# F/CMVSS Noncompliance Recall

## 53501 Tire and Loading Information Label Incorrect

**Reference Number:** N162053501  
**GWM Number:** 2053501  
**Revision Description:** This bulletin is being revised to change the Labor Code. Please discard all previous copies of bulletin 53501.

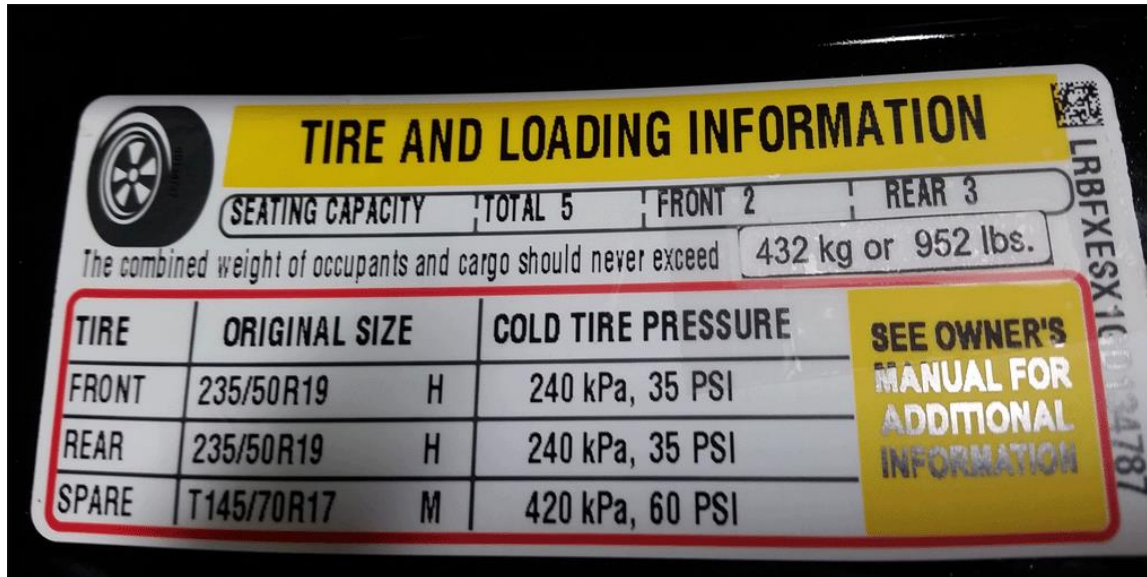
2. Locate the tire and loading information label (1).
3. Clean the tire and loading information label with isopropyl alcohol (rubbing alcohol) and a clean shop towel.

4. Perform a single strikethrough of the incorrect weight values (1) with a Sharpie Industrial Permanent Ink marker 13601.

5. Install the overlay label over top of the incorrect weight values as shown above. Assure the label is properly positioned before allowing contact with the original label. The overlay label should be installed between the black and red horizontal lines, after the word “exceed”. Do not cover the VIN on the right side of the label.
6. Close the driver door.
7. CALIFORNIA VEHICLES ONLY: Complete a “Proof of Correction” certificate and provide to the vehicle owner upon recall completion.
